## Planning Commission MEETING AGENDA

Thursday, September 16, 2021 - 1:00 PM  
Council Chambers, Easton Town Office  
14 S Harrison Street

| <b>Docket/Case/Application Number: 21-</b>                                                                    |

The applicant is requesting Architectural Approval for exterior renovation of the existing Wendy's fast-food restaurant.

SHEET NAME  
EXTERIOR ELEVATIONS

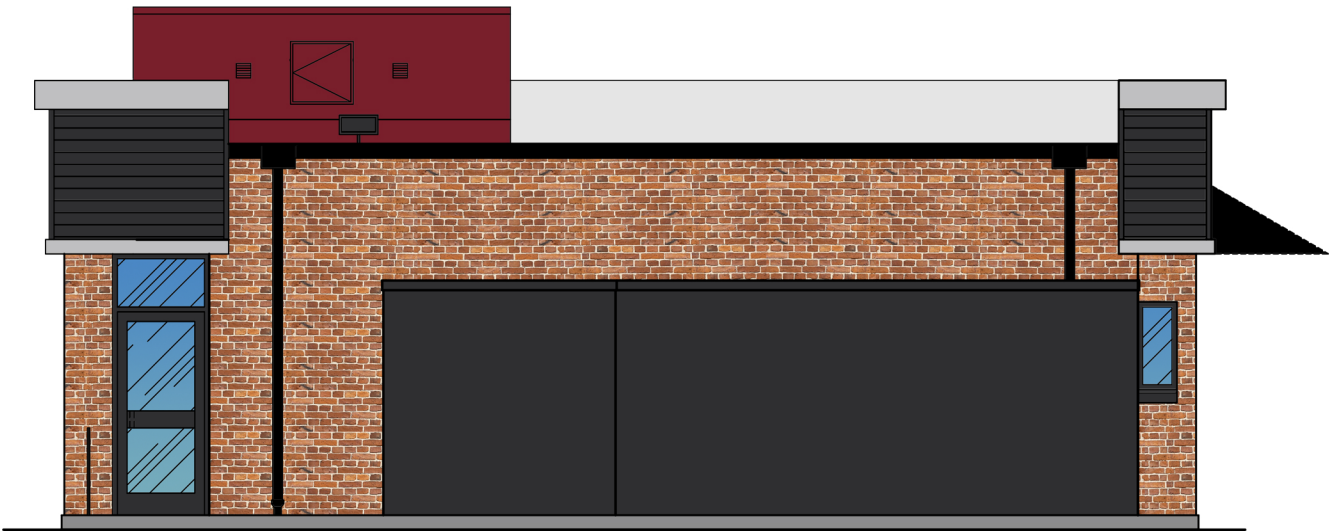
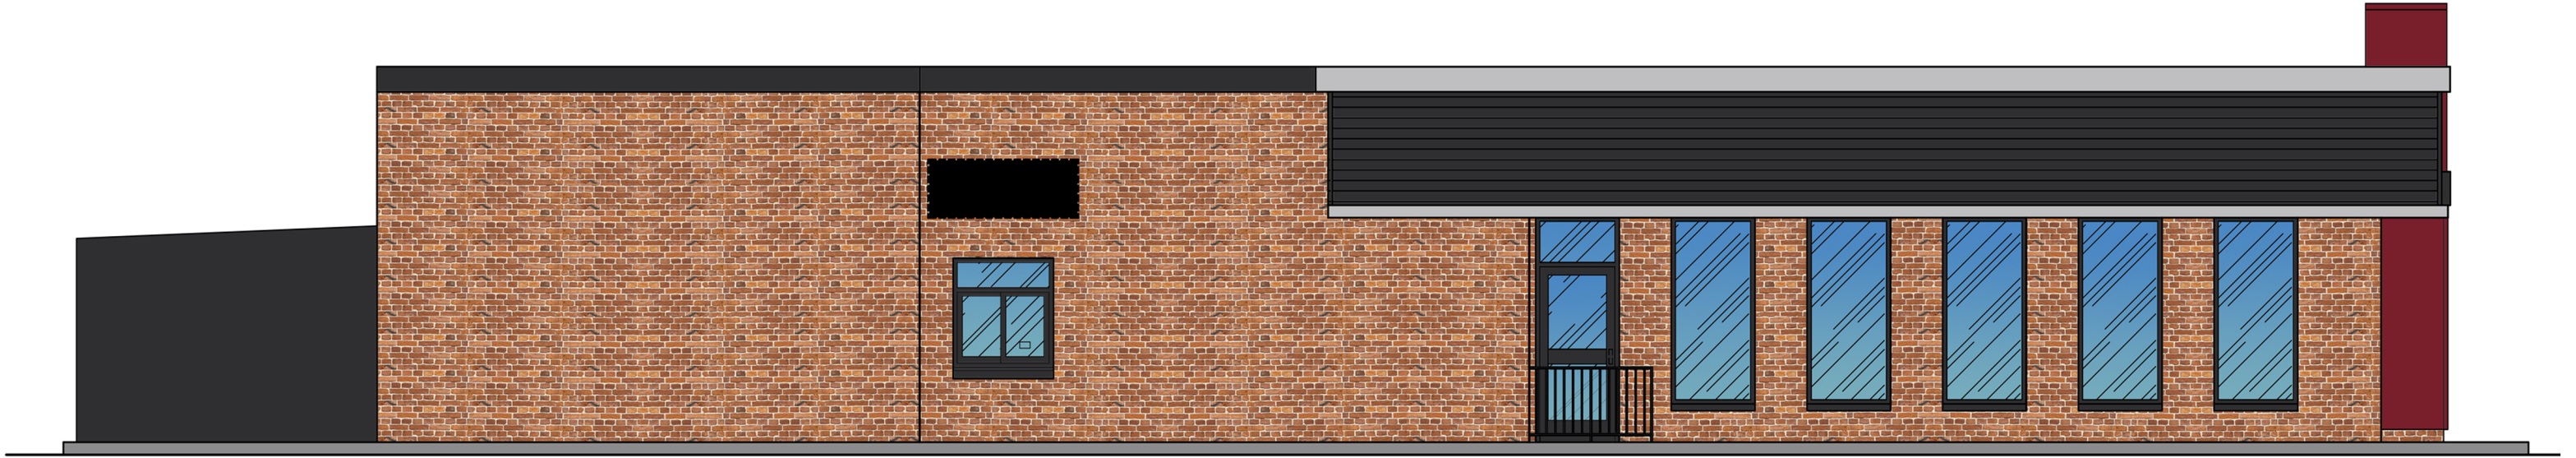
- This issue is before the Commission to approve or deny the architectural renderings of the Wendy's – Fast Food Restaurant.
- Upon Planning Commission decision, applicant will need to obtain a Grading Permit Application and Certificate of Occupancy & Signage Application approval and appropriate building permits for the exterior building.
- **APPROVE the architecture Request.** If -
- The Commission finds that the proposed site plan is in accordance with the Zoning Ordinance as outlined above.
- **DENY the architecture Request.** If -
- The Commission finds that the proposed site plan is not in accordance with the Zoning Ordinance as outlined above and is so off the mark that a brand-new application should be submitted.

Based on the information provided in the application, Staff recommends the Commission **APPROVE the architecture for the proposed Wendy's – Fast Food Restaurant subject to the following conditions:**

- The applicant submits a Grading Permit Application and Site Plan, for Staff level review, depicting the location and any associated changes.
- The applicant submits a Certificated of Occupancy Update & Signage Application for Staff review, depicting the location of sign placement and details.

# Fast-Food Restaurant with Drive-Through Window (934)

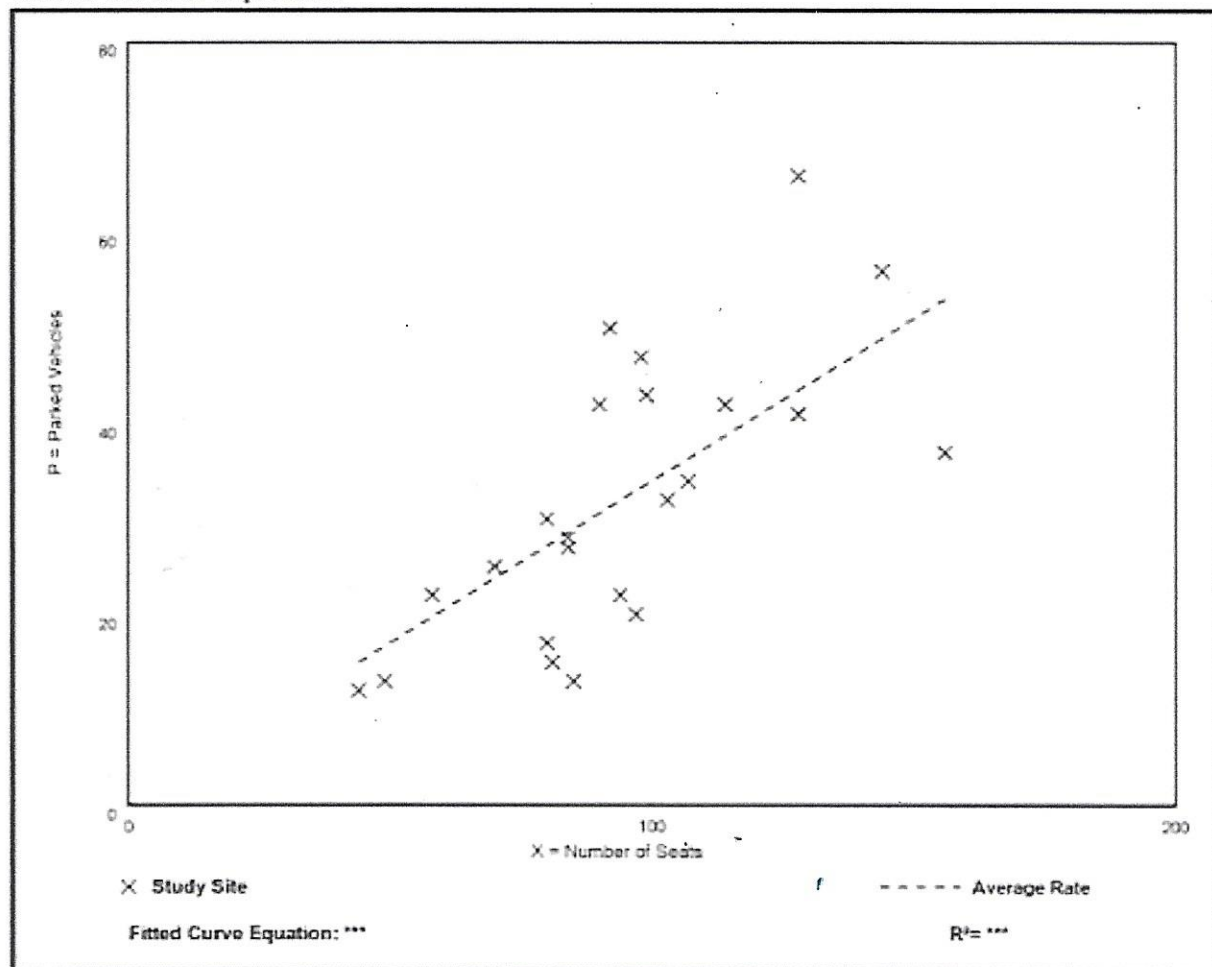
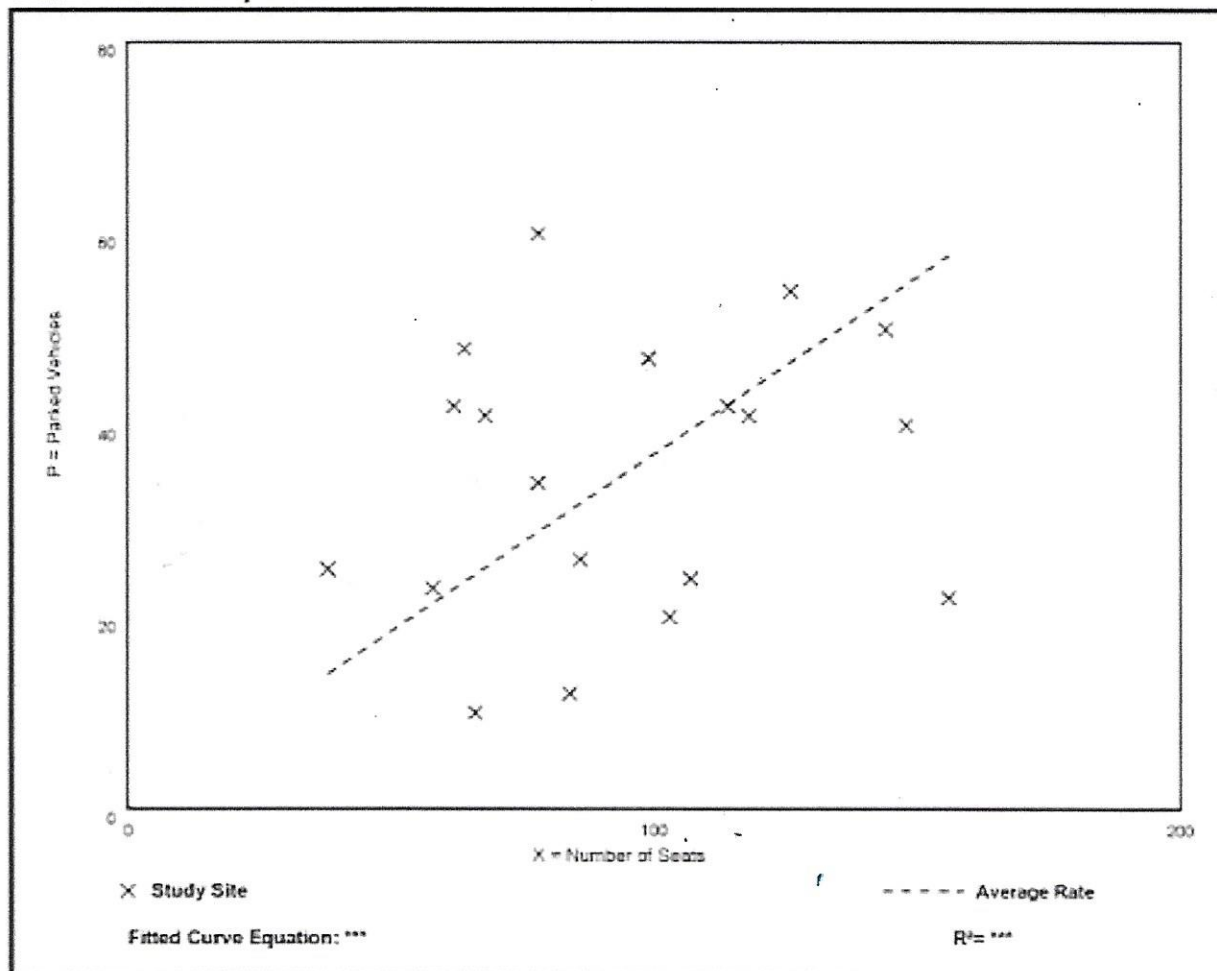
Two graphs show the Peak Parking Demand per Seat, based on surveys of similar locations throughout the country. Page 1 is for a typical weekday and page 2 is for a typical Saturday. The average rate is typically utilized when determining whether parking is adequate to meet demand.

- As shown on page 1, the average weekday peak parking demand rate is 0.34 spaces/seat. Since our site has 56 seats, this would equate to a peak weekday parking demand of 19.04 spaces.
- As shown on page 2, the average weekend peak parking demand rate is 0.37 spaces/seat. Since our site has 56 seats, this would equate to a peak weekend parking demand of 20.72 spaces.

1 MAIN ENTRANCE ELEVATION (RIGHT-SIDE)  
SCALE: 1/4" = 1'-0"

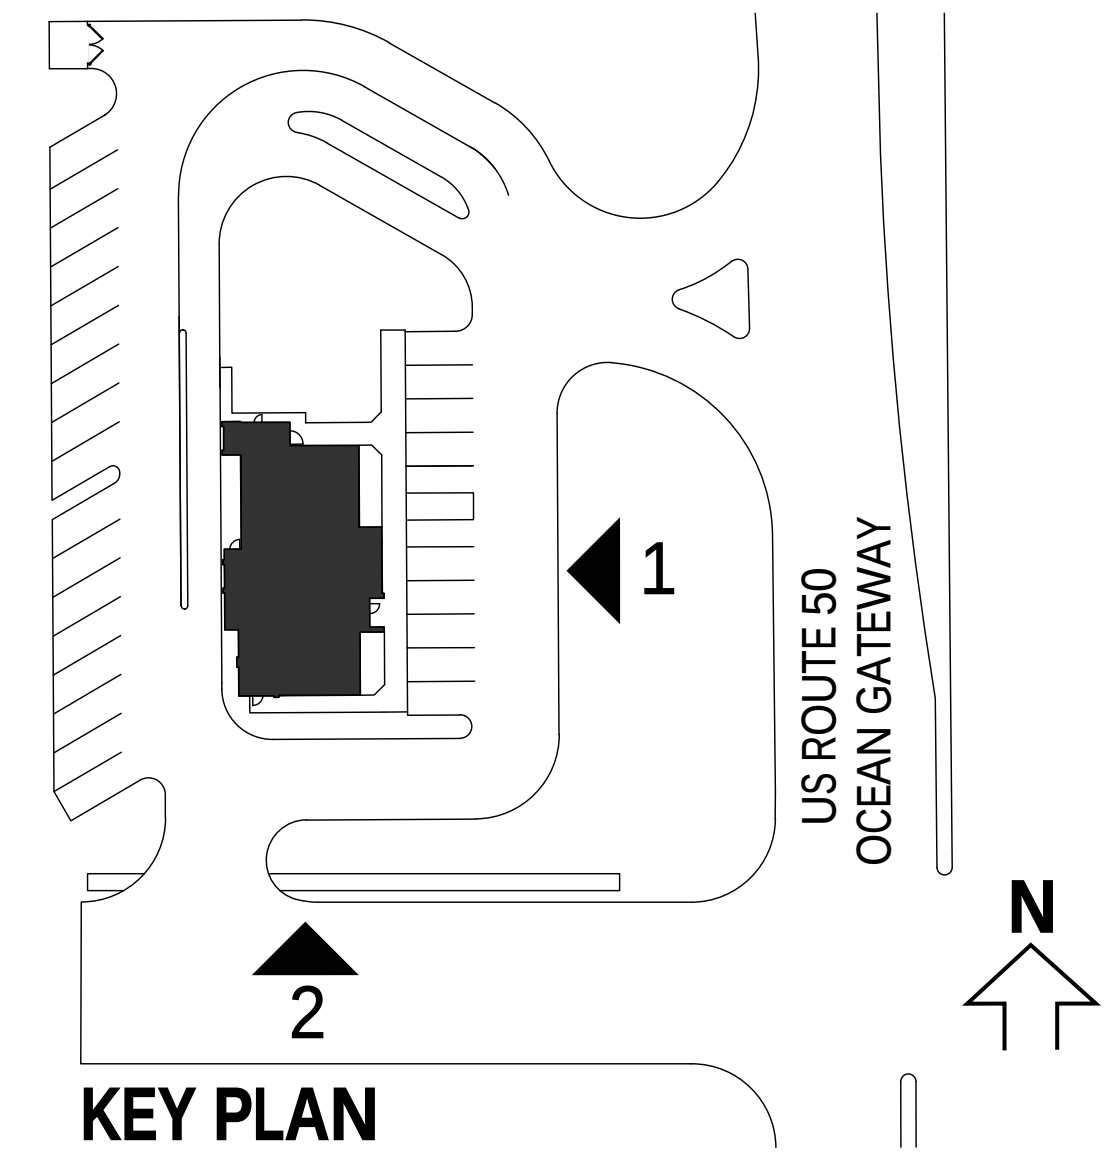
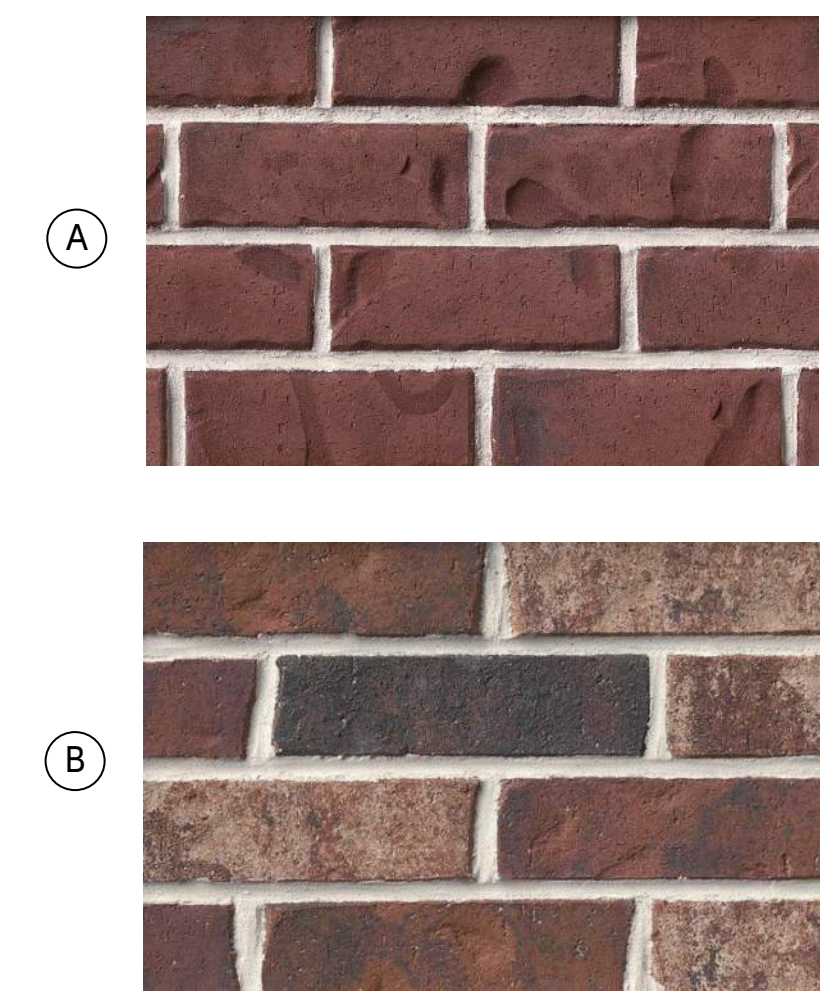
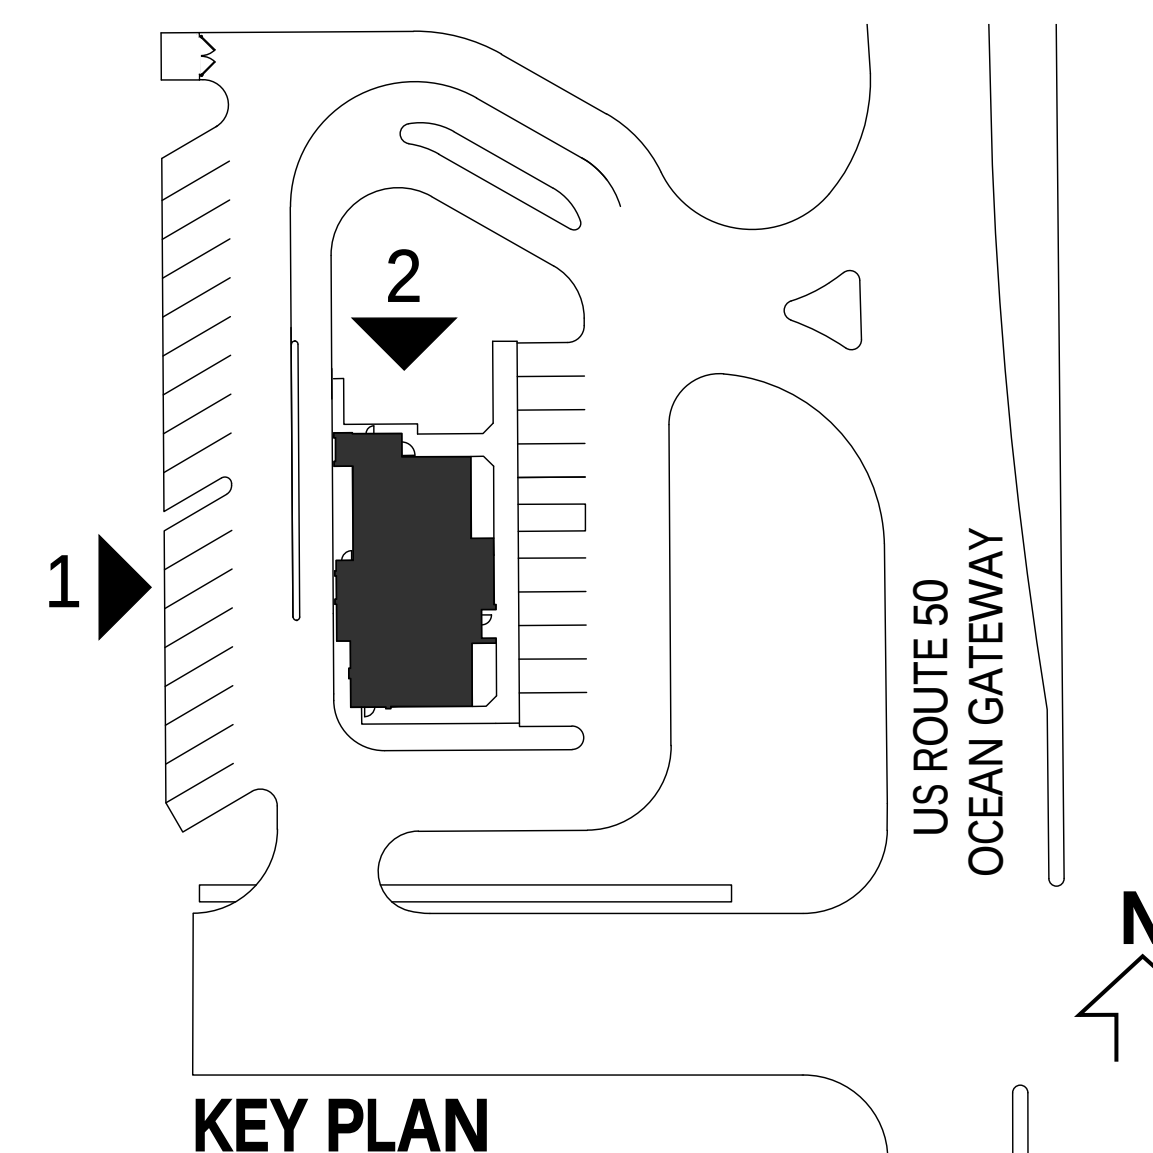
- This issue is before the Commission to approve or deny the Site Plan, Parking Waiver Request and its architectural renderings of the Burger King – Fast Food Restaurant.

Based on the information provided in the application, Staff recommends the Commission **APPROVE the sketch site plan, architecture and Parking Waiver for the proposed Burger King – Fast Food Restaurant subject to the following conditions:**

- The applicant submits a Development Site Plan, for Staff level review, depicting the location and any associated changes.
